ADDENDUM 2
Via E-Mail
DATE: May 26, 2020

Contract 19-C-00053 David L Tippin Facility Solids Processing System Improvements

SPLITTER BOX DETAILS FOR BYPASS PUMPING

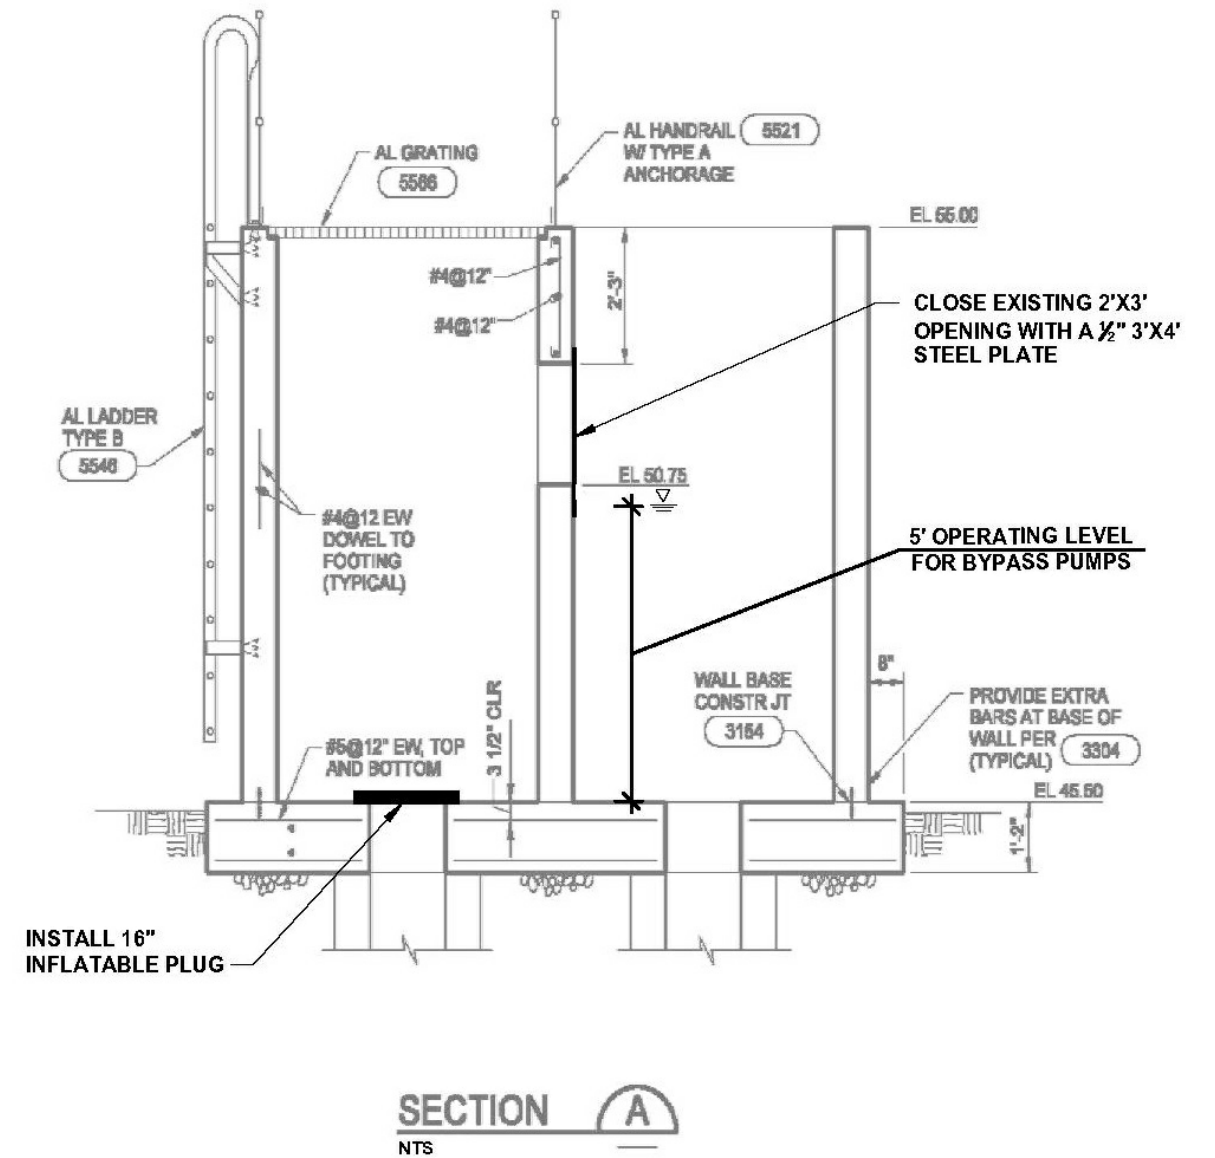
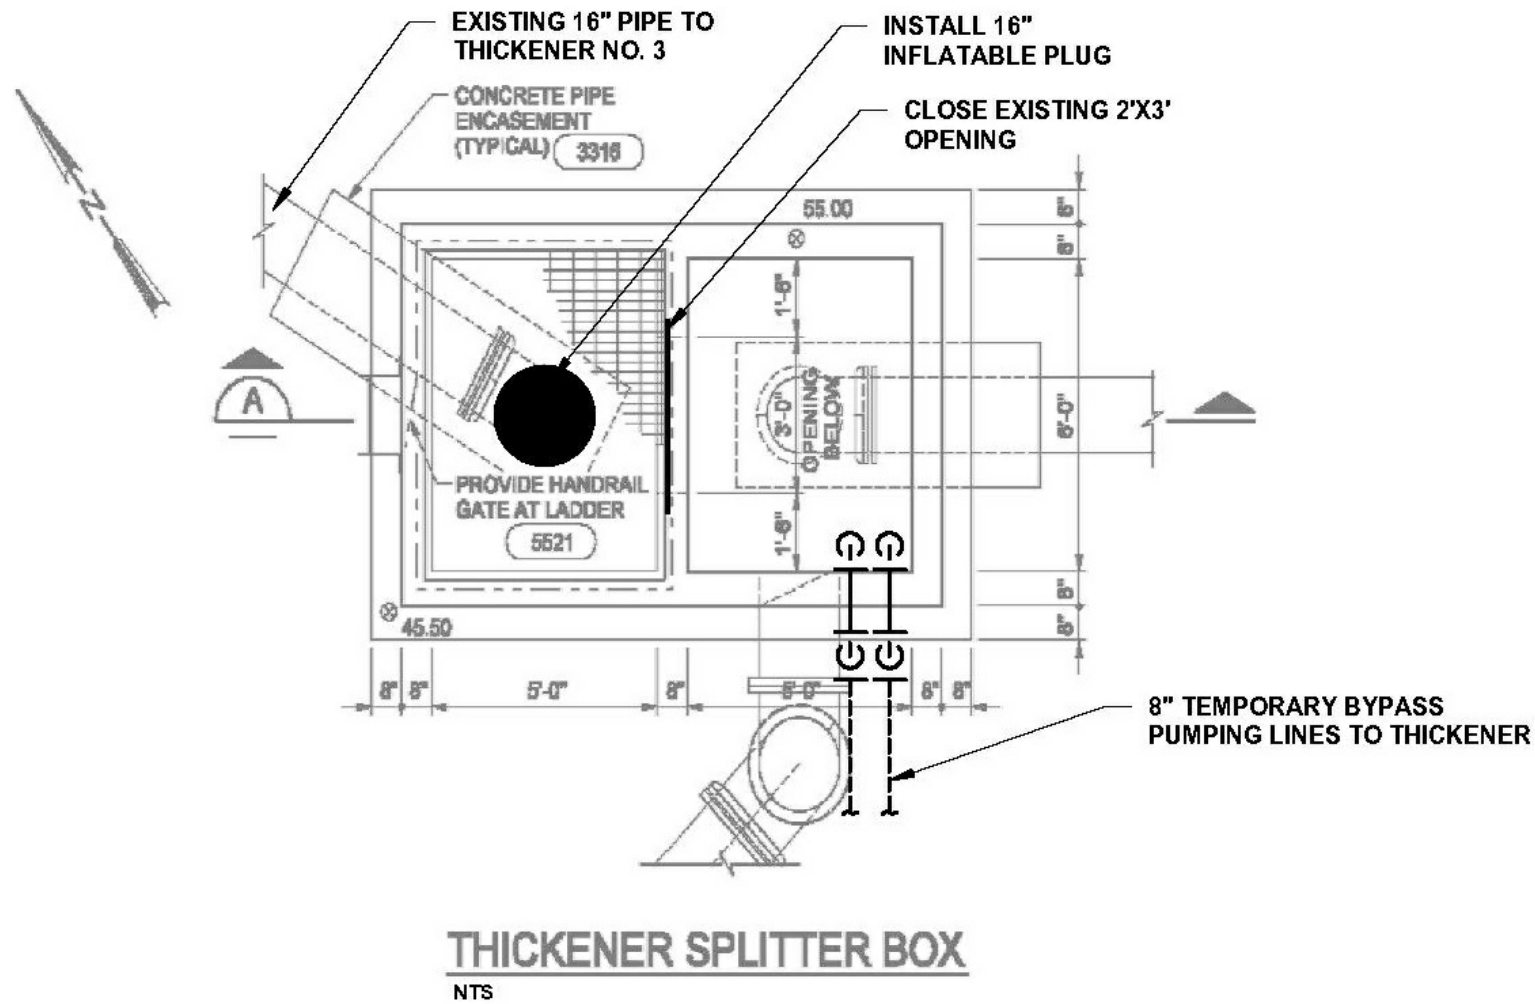
Item 1: Replace plan sheet 23 with the attached plan sheet 23.
